World Forum for Harmonization of Vehicle Regulations**Working Party on General Safety Provisions****126th session**

Geneva, 10-13 October 2023

Amendments to External Projections Regulations:**UN Regulation No. 61 (External projections of commercial vehicles)****Proposal for the 01 of amendments to UN Regulation No. 61
(External projections of commercial vehicles)****Submitted by the expert from Germany on behalf of the Task Force on
UN Regulation No. 46***

Figure 1

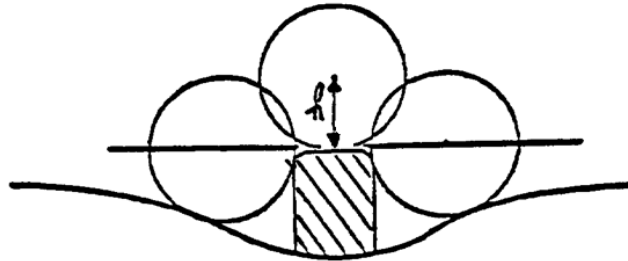
- 6.12.4.2. If the dimension of the projection of a component which is mounted on a surface other than convex cannot be determined by simple measurement, it shall be determined by the maximum variation of the distance of the centre of a 100 mm diameter sphere from the nominal line of the panel when the sphere is moved over and is in constant contact with that component. Figure 1 shows an example of the use of this procedure.

Model A

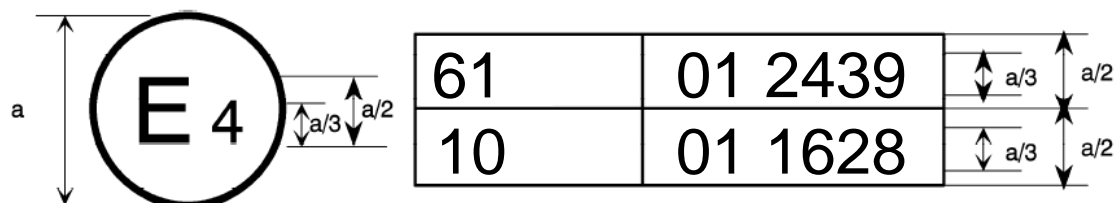
The above approval mark affixed to a commercial vehicle shows that the vehicle type concerned has, with regard to external projections, been approved in the Netherlands (E 4) pursuant to UN Regulation No. 61 and under approval number 012439. **The first two digits of the approval number indicate that UN Regulation No. 61 already included the 01 series of amendments when the approval was granted.**
